AGENDA

The Columbia Architectural Design Review Team will meet on Tuesday, June 7th, 2022 at 8:00 a.m. in Conference Room A on the basement level of City Hall, 700 N. Garden Street to consider the following:

8:10 AM 22-0119 - 2008 Main Street - Modify Façade Of Existing Building
Request from Richard Thompson on behalf of Ritco Group, Inc for façade
modifications at [2008 S. MAIN STREET.](#)

SHEET #:
DA-2

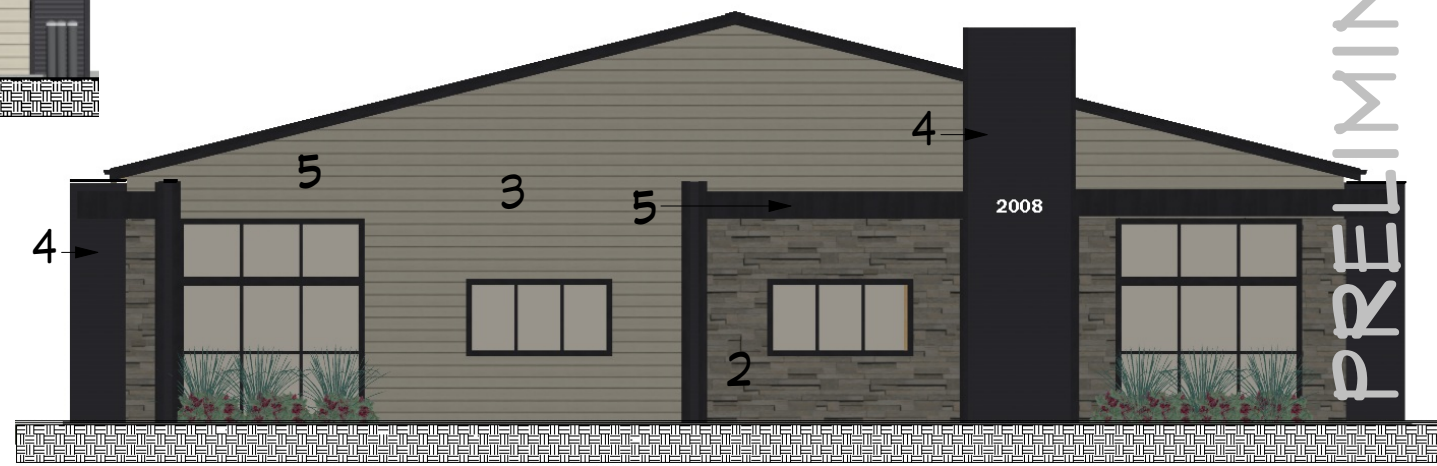
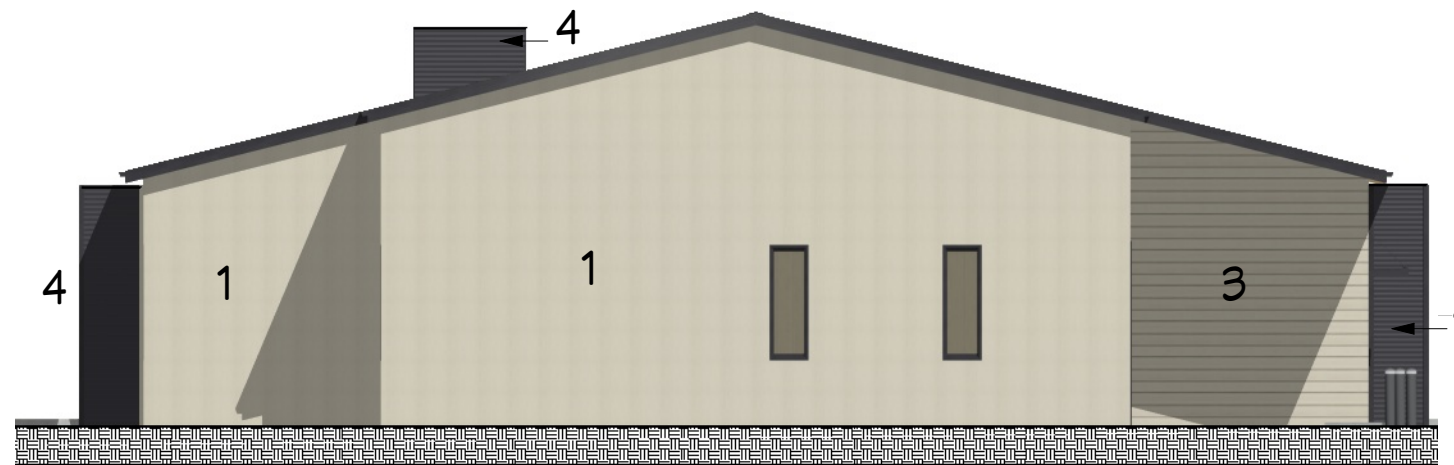
This request is for the façade modification of an existing pre-fabricated metal building. The modification consists of recladding of a corrugated metal façade with fiber cement board and additional window openings including a front tower addition.

- The front facade consists of the recladding of metal with fiber cement board and the material change from brick to a ledge stone. Alternative compliance has been requested to allow for corrugated metal accents to the front façade. These materials meet the design standards as referenced with the exception of corrugated metal.

- A left and right elevation indicate the primary facade materials of a fiber cement board and batten including fiber cement board lap siding. In addition, a metal clad awning has been added over door openings. These materials meet the design standards as referenced.

- The rear elevation consists of the primary façade materials of board and batten lap siding including horizontal siding material consisting of fiber cement board. These materials meet the design standards as referenced.

- Alternative compliance has been requested to allow for minor sections of corrugated metal to be integrated in the faced change located at a proposed tower and end cap of the elevations.

EXTERIOR ELEVATIONS

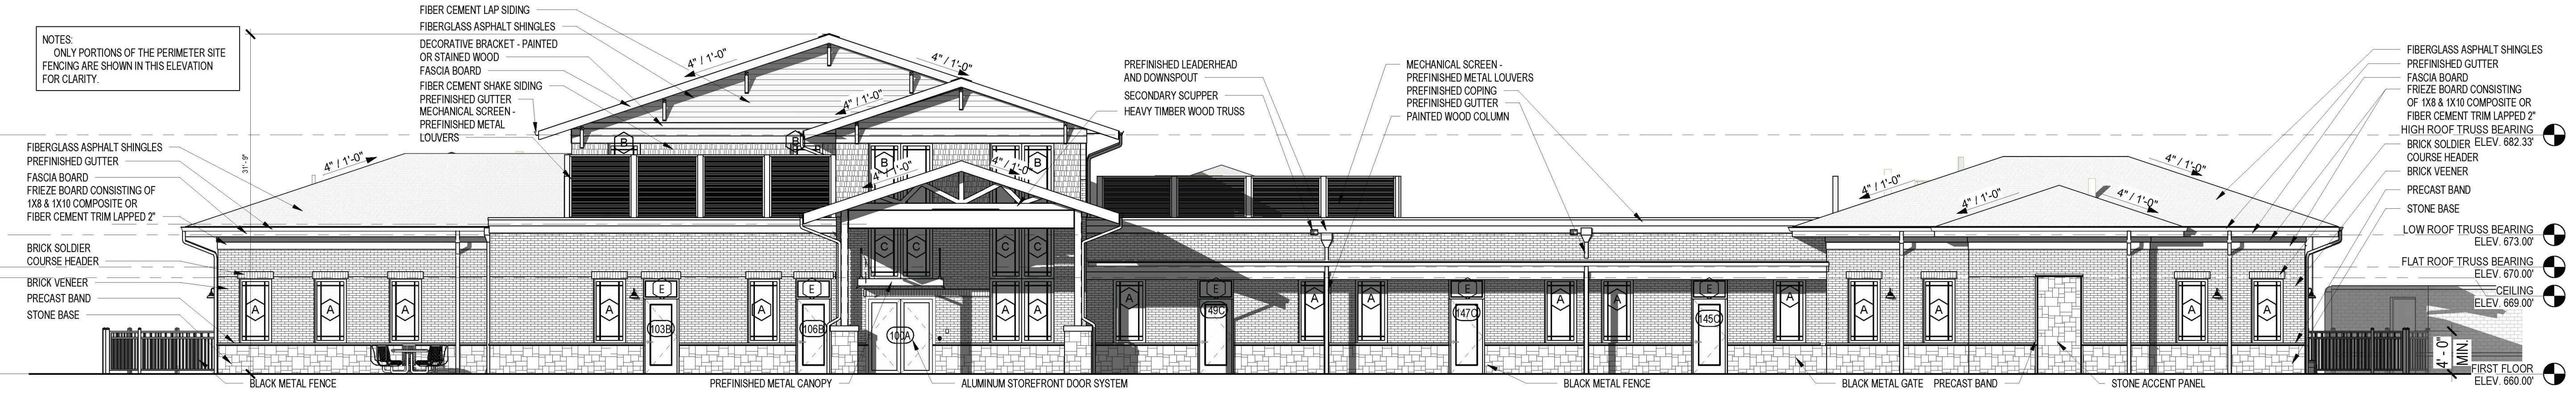
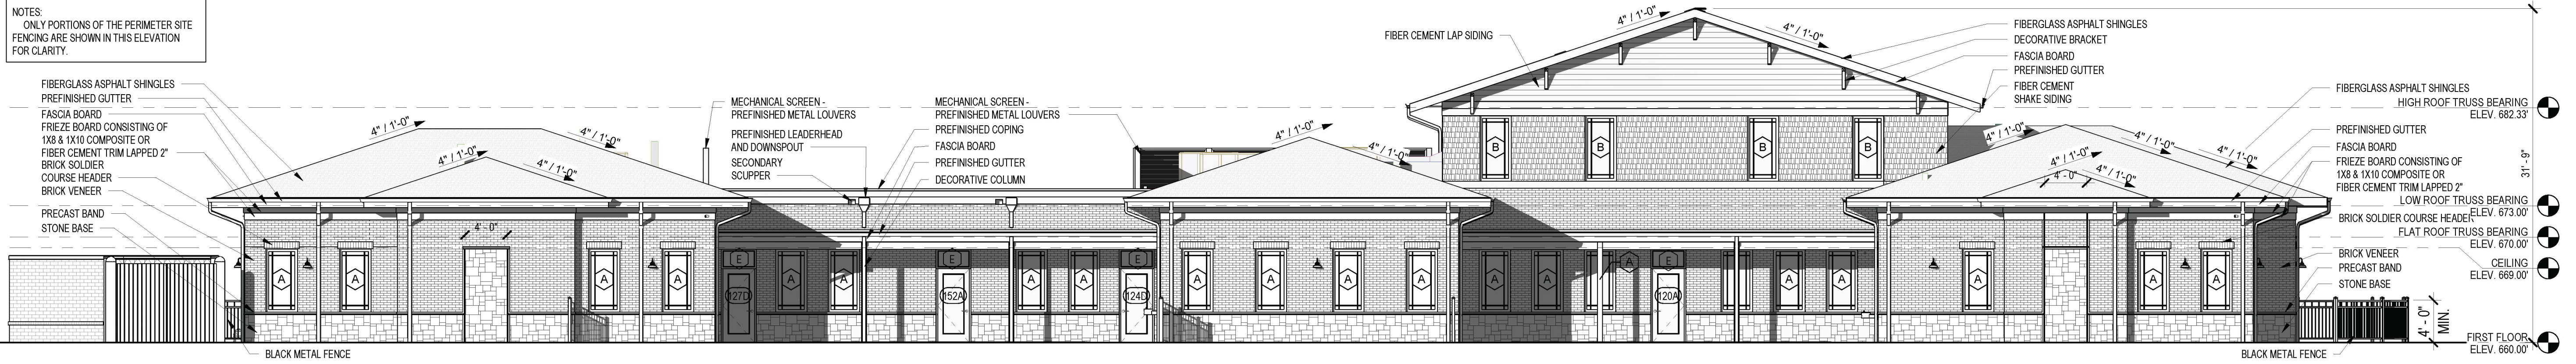
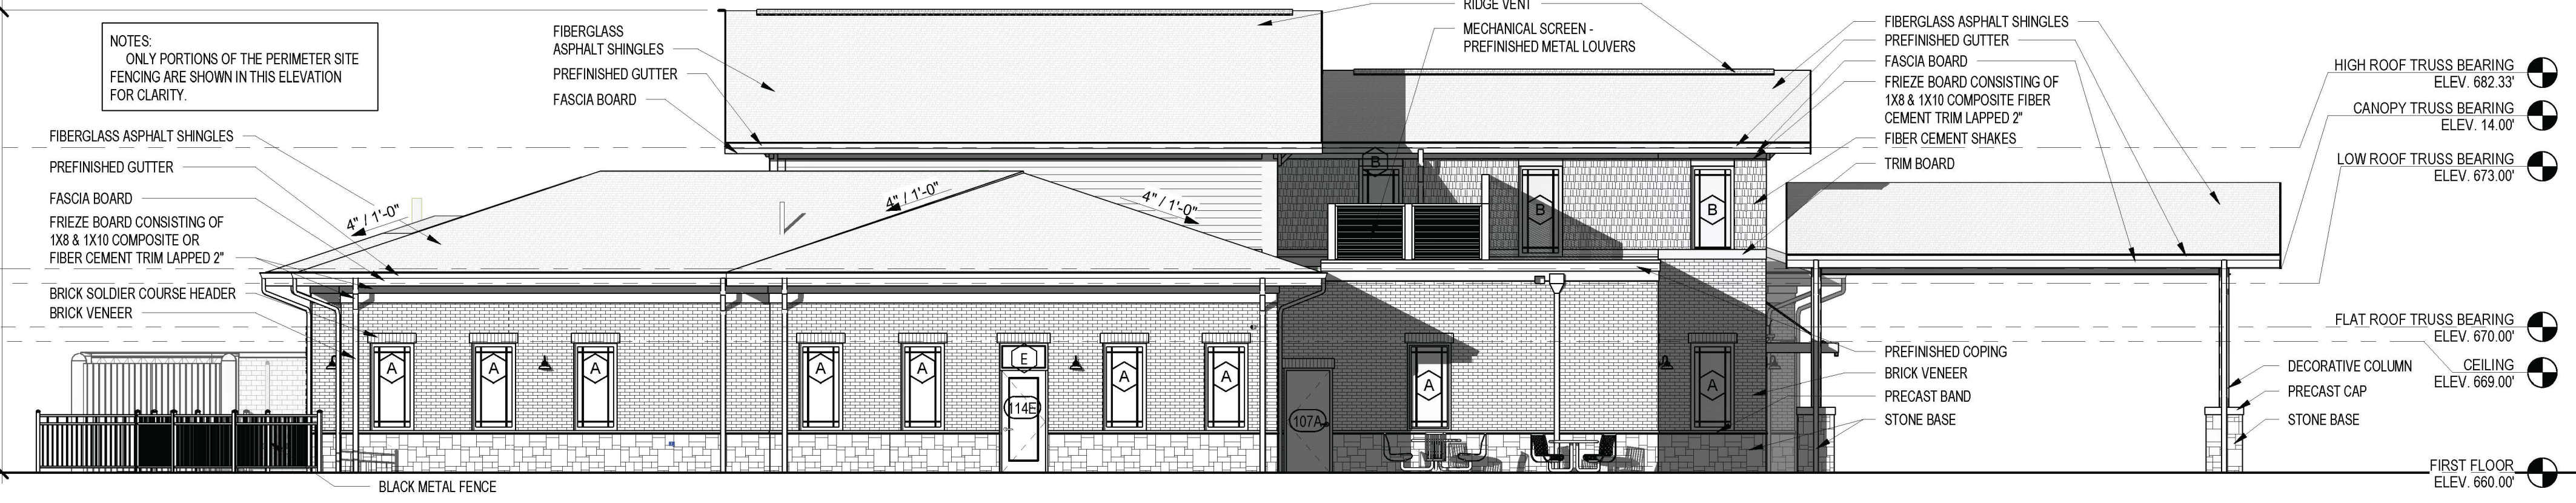
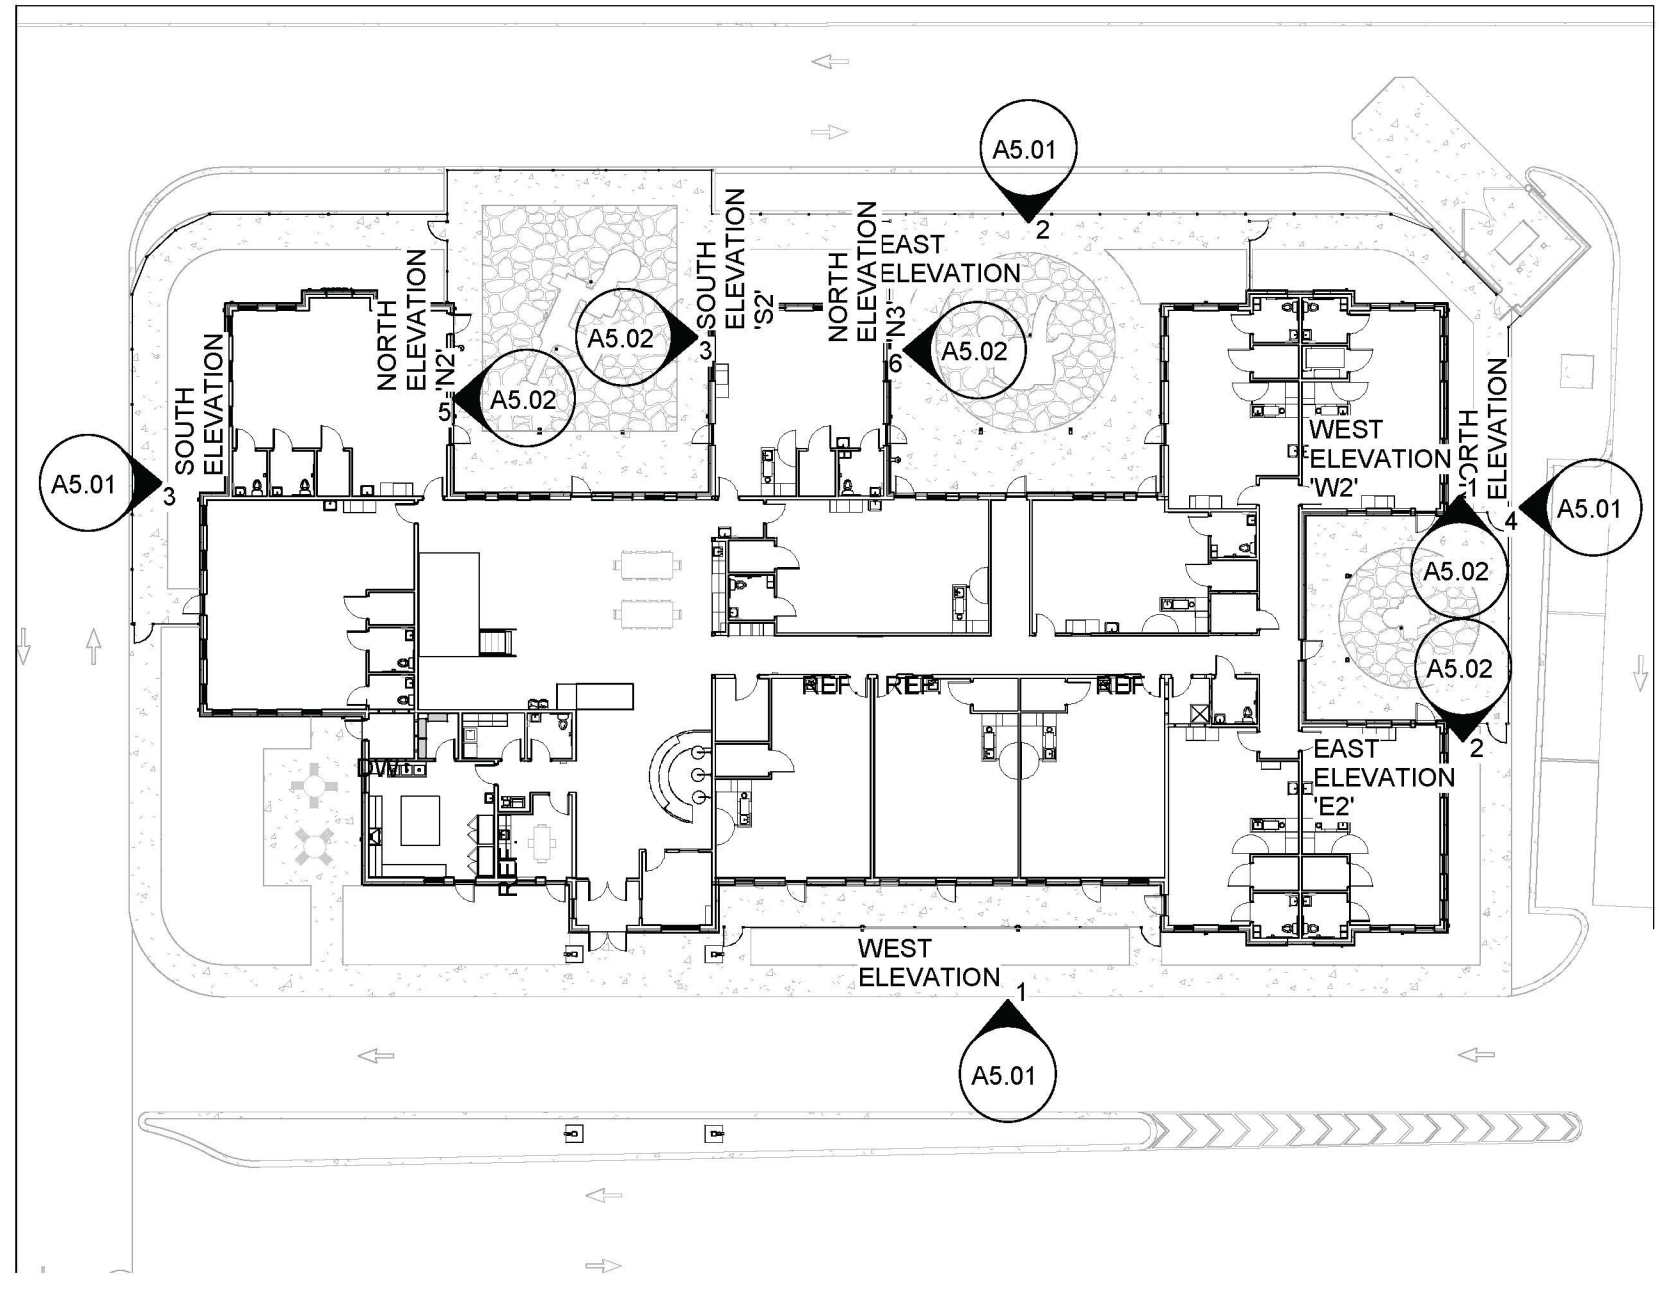
This request is for the new construction of a day care center to be located in a proposed mixed use planned unit development currently under review before the Planning Commission. The primary façade materials consist of brick with a stone base. Additional cladding materials of the gable consist of fiber lap siding and cedar shake siding.

- The front facade (west elevation) consists of a primary material of brick accented by a stone base and fiber cement board clad gables. These materials meet the design standards as referenced with no unbroken façade plane less than 35’.
- The east elevation consists of a primary material of brick accented by a stone base. These materials meet the design standards as referenced with no unbroken façade plane less than 35’
- The south and north elevation consist of a primary façade material of brick accented by a stone base. These materials meet the design standards as referenced with no unbroken façade plane less than 35’. As noted, the mechanical units on the north elevation is proposed to be screened by prefinished metal louvers.
